# Sitlika Creek: the Bad, the Ugly and the Really Ugly

Brad Fairley, MES

# Background

PLAN VIEW  
1:200

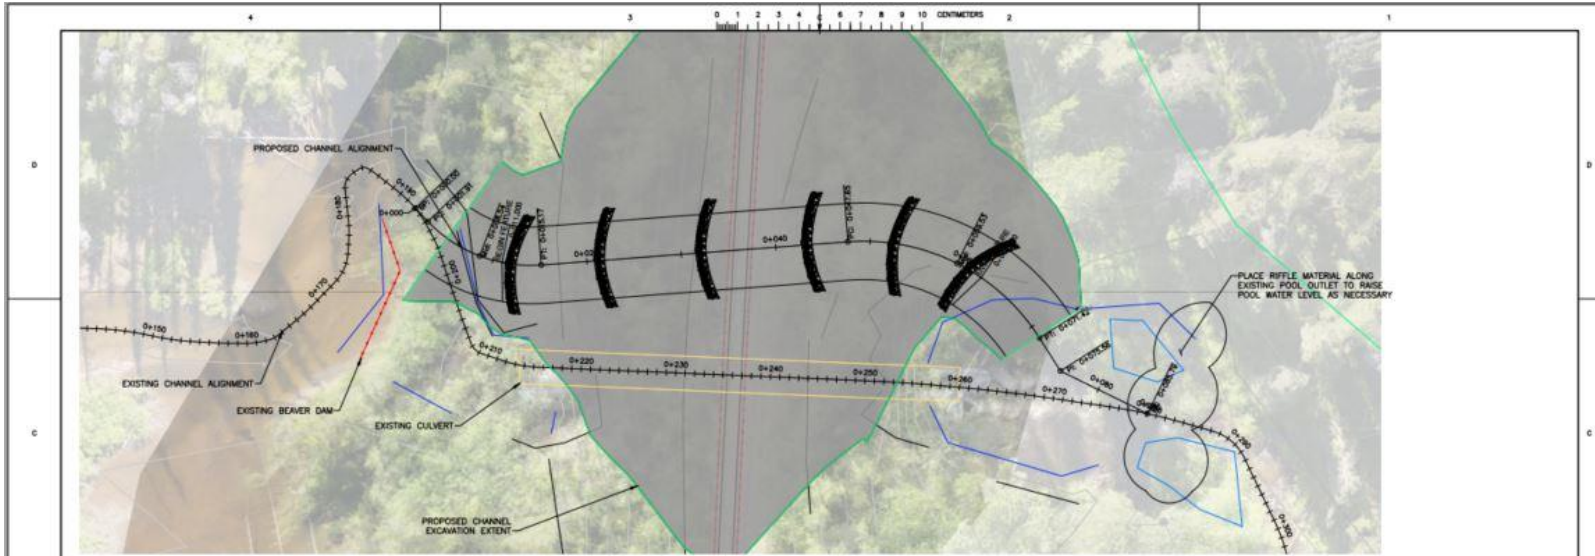
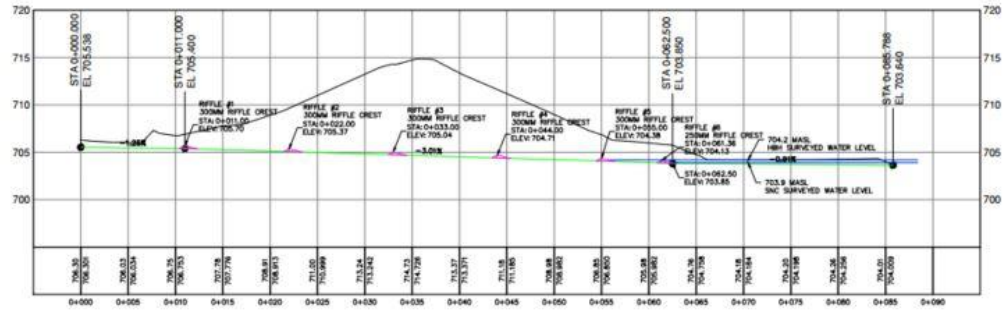
- RR asked 5SSR to do a post-mortem
- Issues
  - Dimension (trapezoidal channel with an ER of 1)
  - Pattern (pool spacing was 2X the existing stream)
  - Profile (too steep)
  - Structures (too small, not keyed into the bed or banks, did not centre the flow)
  - Erosion control measures were inadequate

# Design

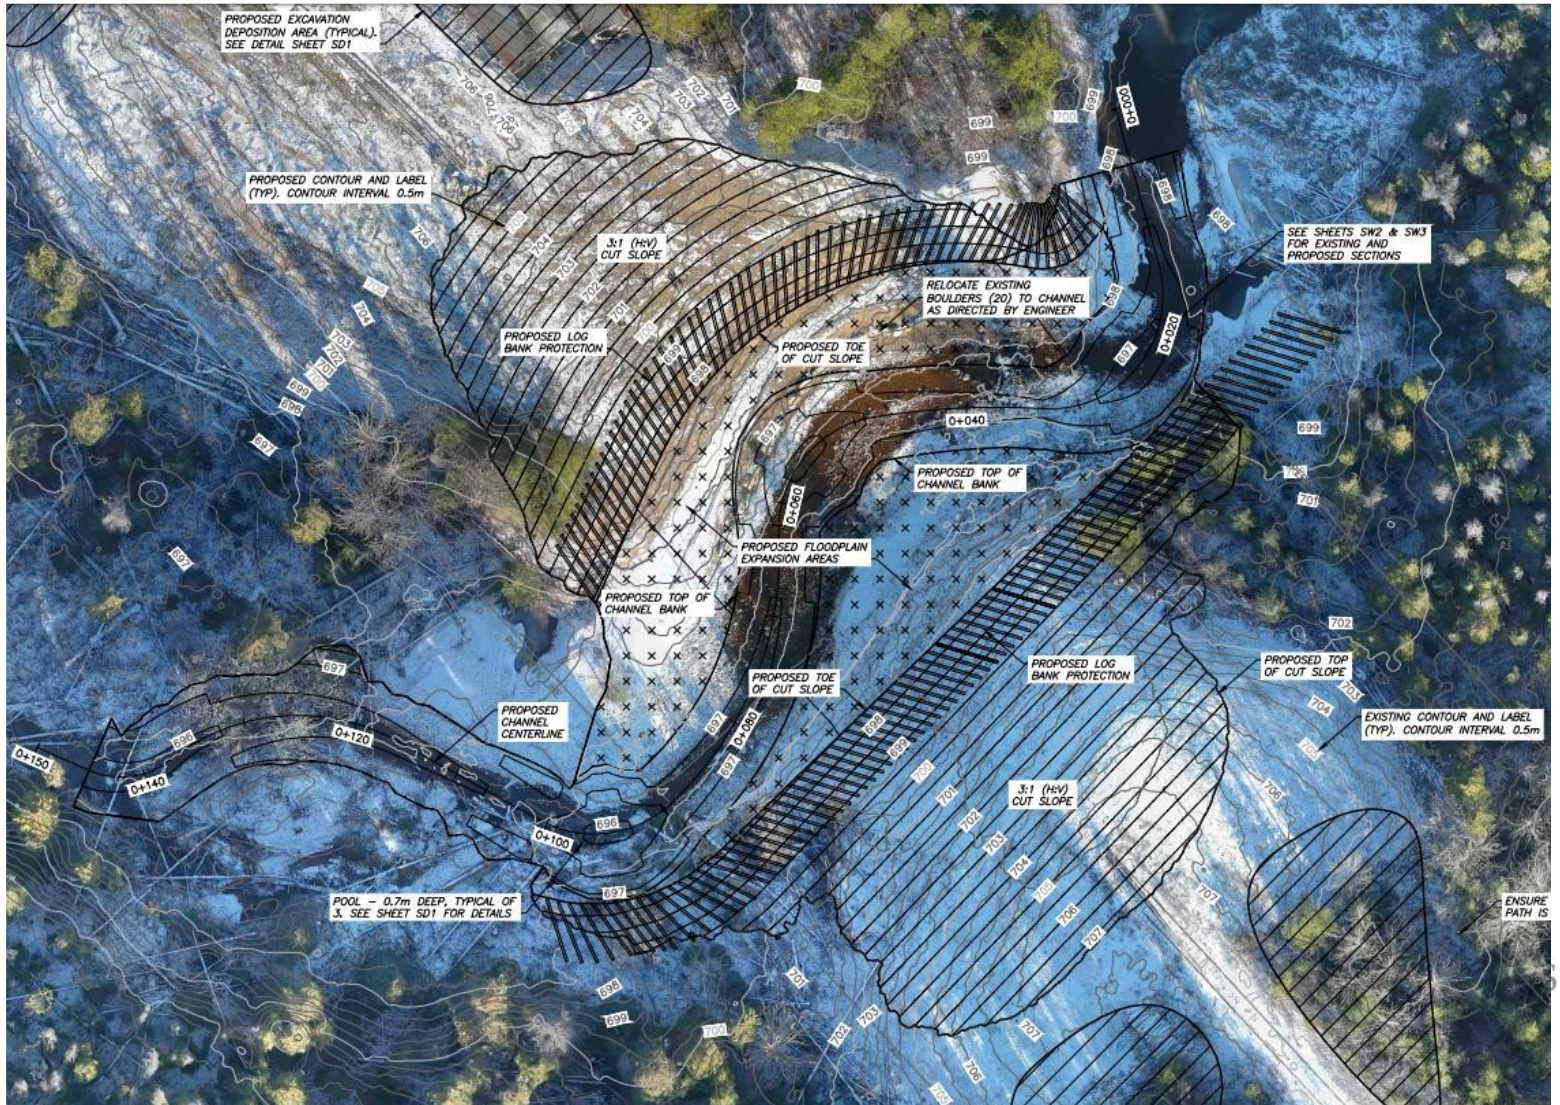
- RR asked 5SSR to coach the designer
- Improvements
  - Added a floodplain
  - Flattened the slope on the cut through the embankment
- Issues
  - No change in slope / no grade control
  - Channel is too large
  - Nothing to hold TOB
  - Scour on the floodplain
- Conclusion: It would fail if constructed
